**REGIONAL INTEGRATED LOOP SYSTEM
PHASE 3B INTERCONNECT PROJECT**

PEACE RIVER MANASOTA REGIONAL WATER SUPPLY AUTHORITY

ADDENDUM NO. 3

Date Issued: June 7, 2019

REGIONAL INTEGRATED LOOP SYSTEM
PHASE 3B REGIONAL INTERCONNECT PROJECT
PEACE RIVER / MANASOTA REGIONAL WATER SUPPLY AUTHORITY
PIPE SUPPORT FOUNDATION PLAN AND SECTIONS

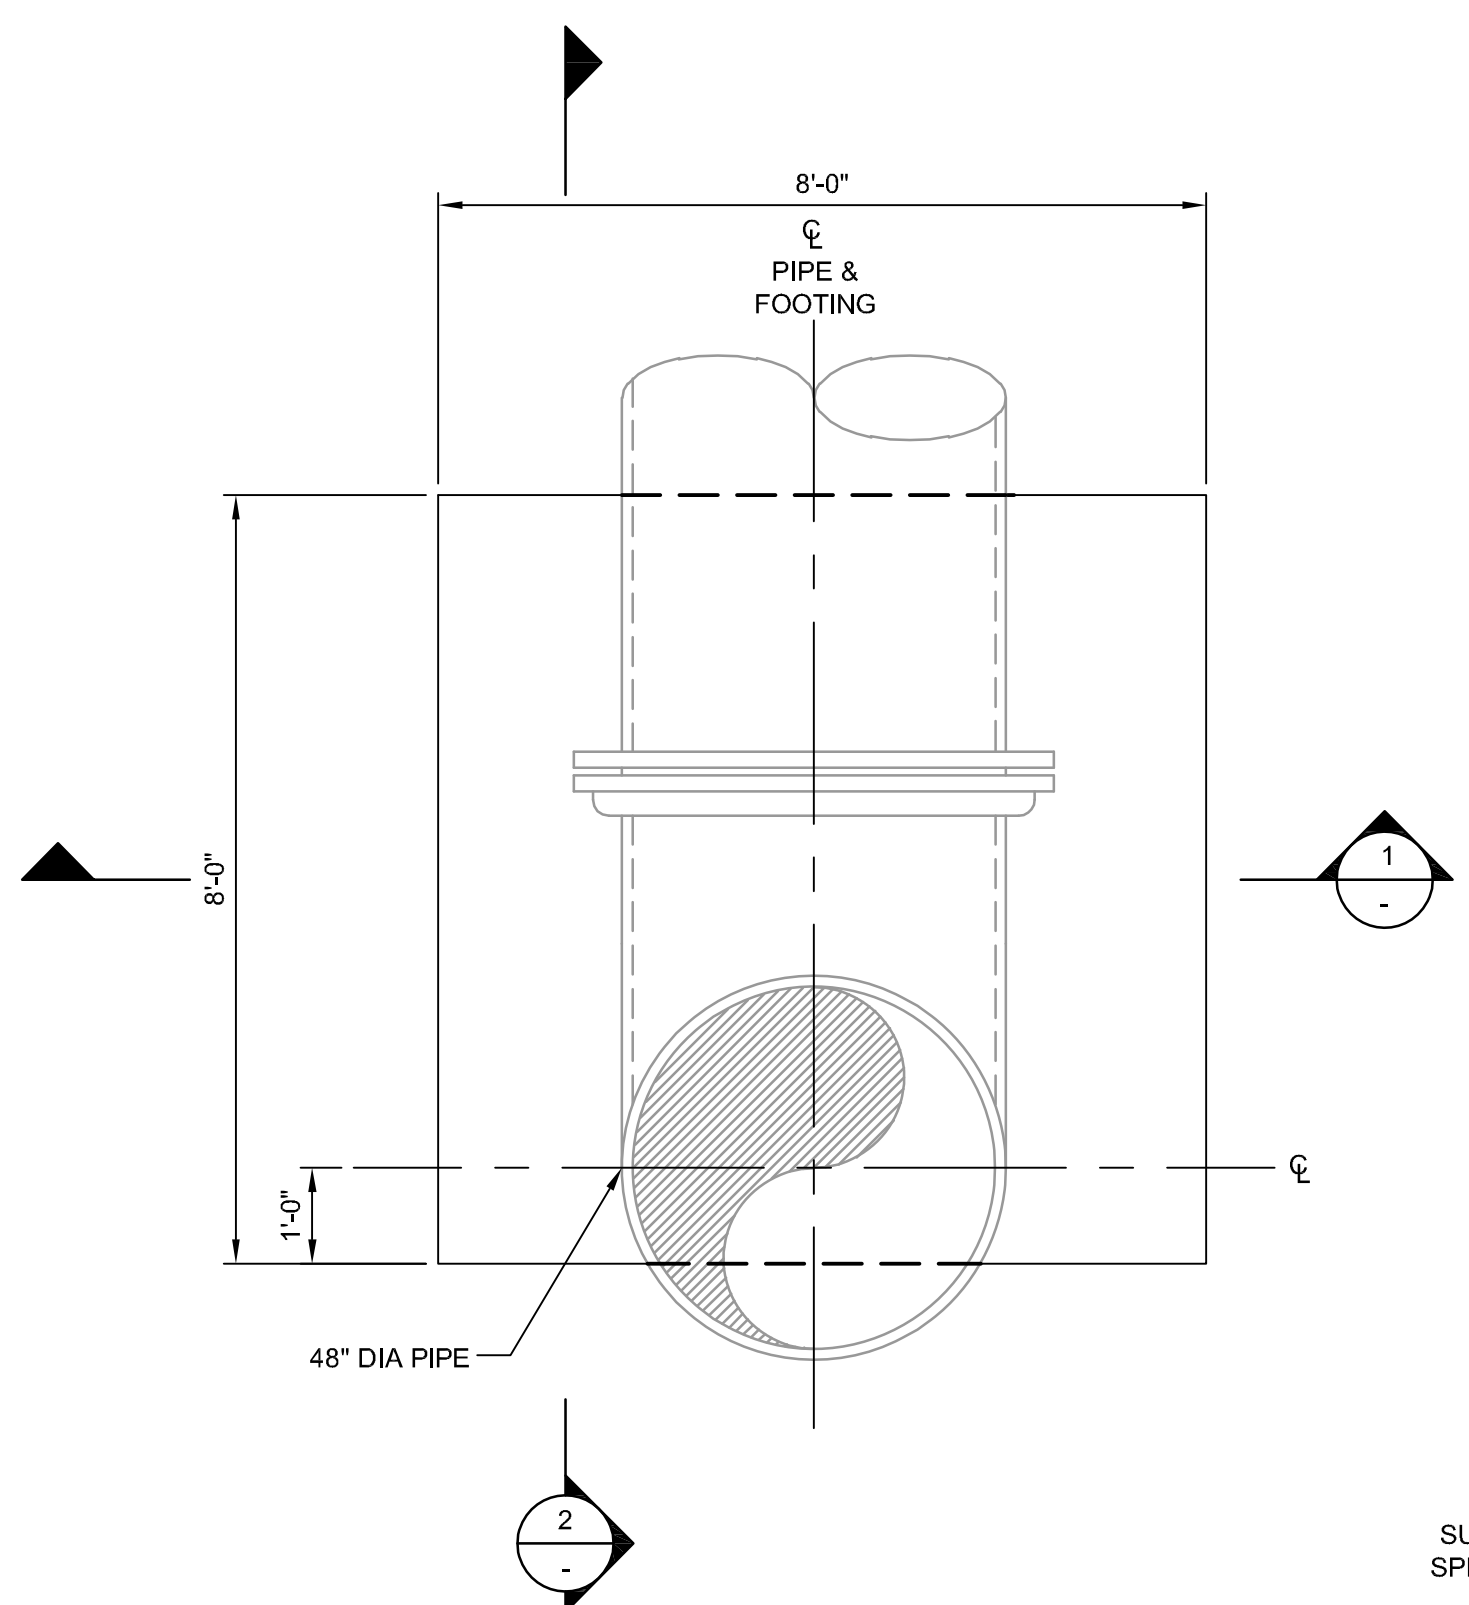
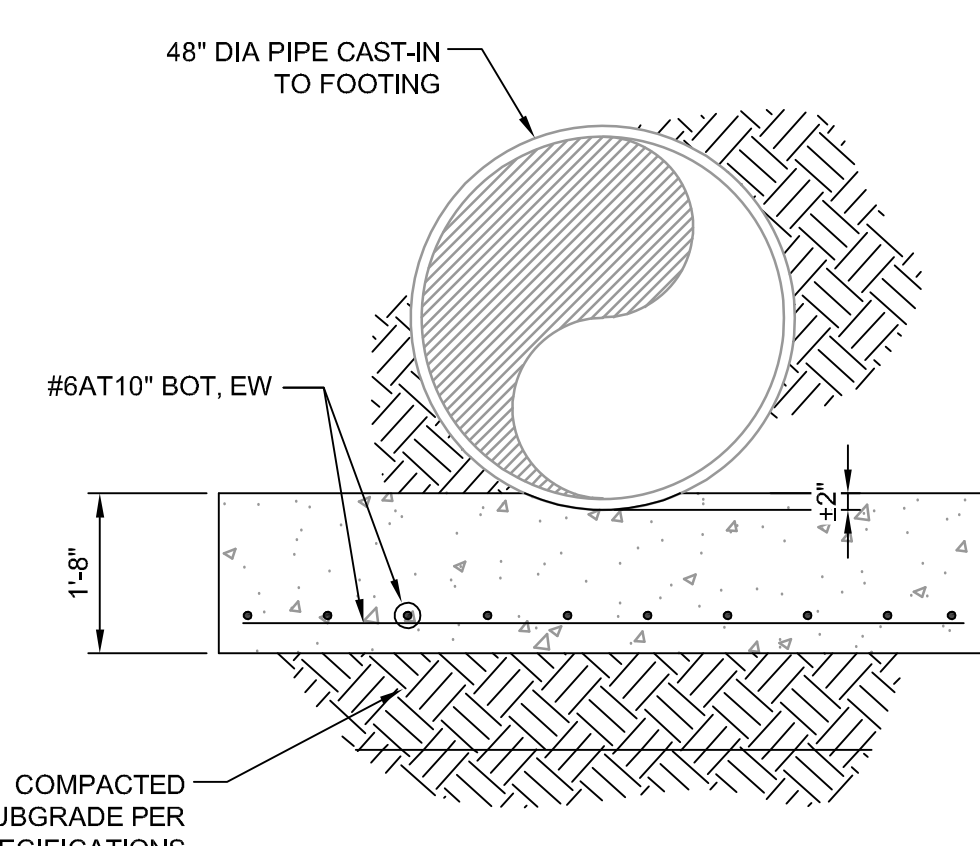
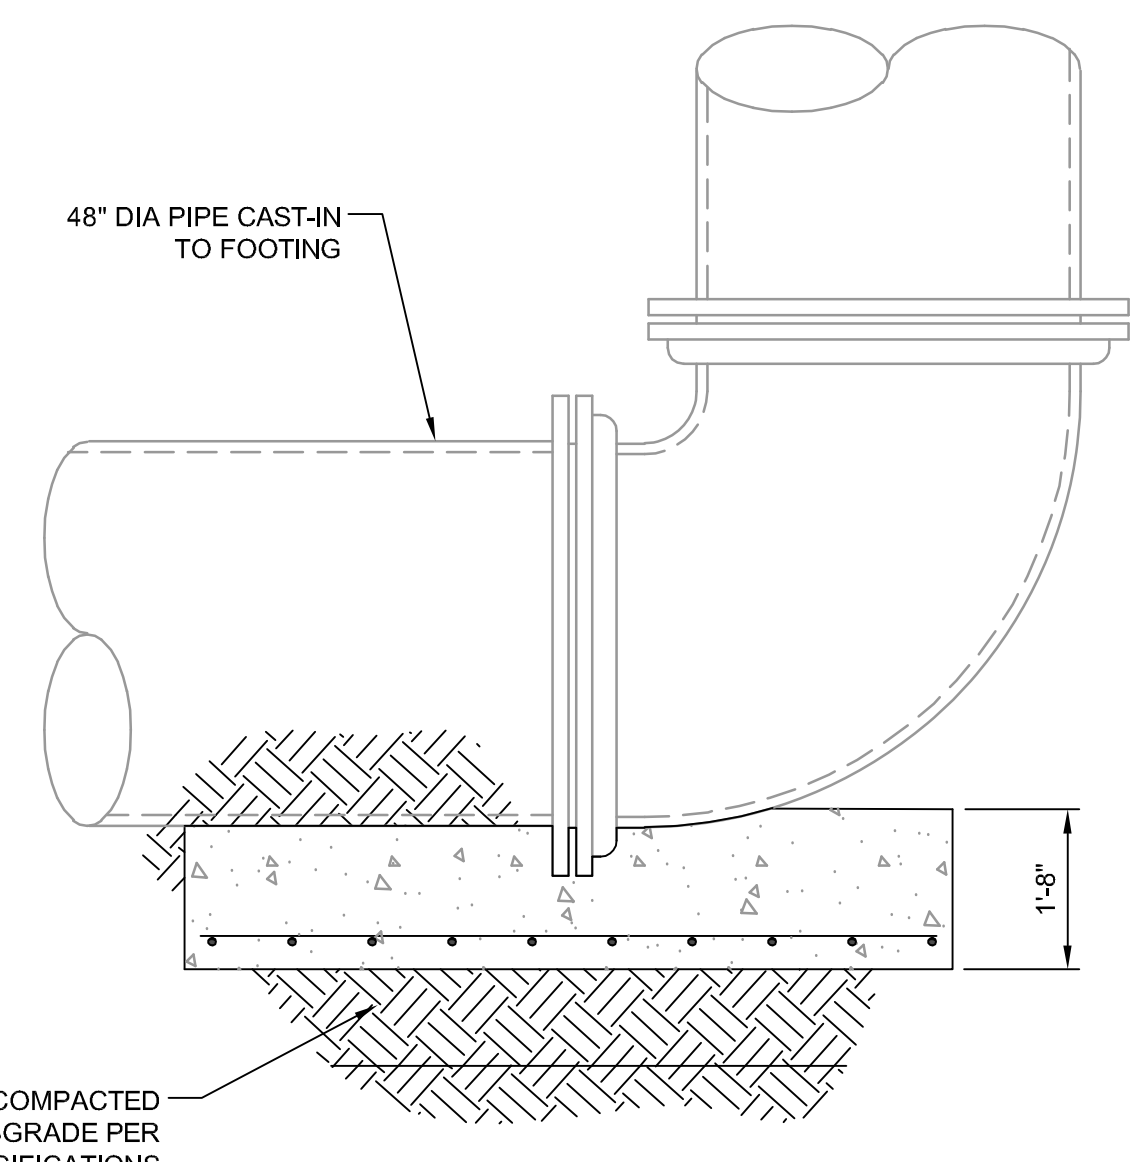
22. **DELETE** the Below Grade Concrete Support Detail on Sheet D1.03 and **REPLACE** with the attached Drawing S1.00 PIPE SUPPORT FOUNDATION PLAN AND SECTIONS.
